Project	IEEE 802.16 Broadband Wireless Access Working Group < http://ieee802.org/16 >	
Title	Proposed MAC header modification	
Date Submitted	2001-03-08	
Source(s)	Huanchun Ye BeamReach Networks 329 North Bernardo Avenue Mountain View, CA 94943	Voice: 650-988-4783 Fax: 650-988-4746 mailto:hyc@beamreachnetworks.com
Re:	This document is submitted in response to 802.16 Letter Ballot #3	
Abstract	This document proposes several changes to the MAC header fields	
Purpose	This document is submitted for consideration by 802.16 in the comment resolution process of Document 802.16/D2-2001.	
Notice	This document has been prepared to assist IEEE 802.16. It is offered as a basis for discussion and is not binding on the contributing individual(s) or organization(s). The material in this document is subject to change in form and content after further study. The contributor(s) reserve(s) the right to add, amend or withdraw material contained herein.

MAC Header Format Change Proposal

Replace Figure 18, Generic MAC Header Format (Uplink), with the following figure:

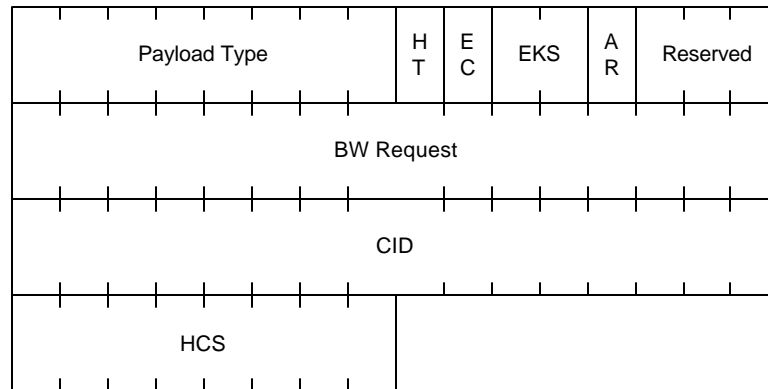
1. Page 50, Line 38, Section 6.2.2

1. We suggest adding a Payload Type field to allow upgrade to future MAC versions. This flexibility is necessary to accommodate requirements of other Task Groups within the 802.16, some of which are still in the process of being defined.

2. The position and format of the Payload Type field should be the same for all header types.
3. The original header formats contain fields for convergence sublayer indications, CSI and CPT. These fields properly belong to the MAC SDU, rather than in the MAC header. Removing them provides a clean layer separation.

4. The original headers contain a packet discard eligibility indicator. It seems very odd to send a packet over the airlink, where the bandwidth resource is at a premium, and then having the receiving MAC discard it. It is better to pass this kind of marking from higher layer to the transmitting MAC, which can decide to discard it if bandwidth is not available. We suggest that this field be removed from the MAC header.
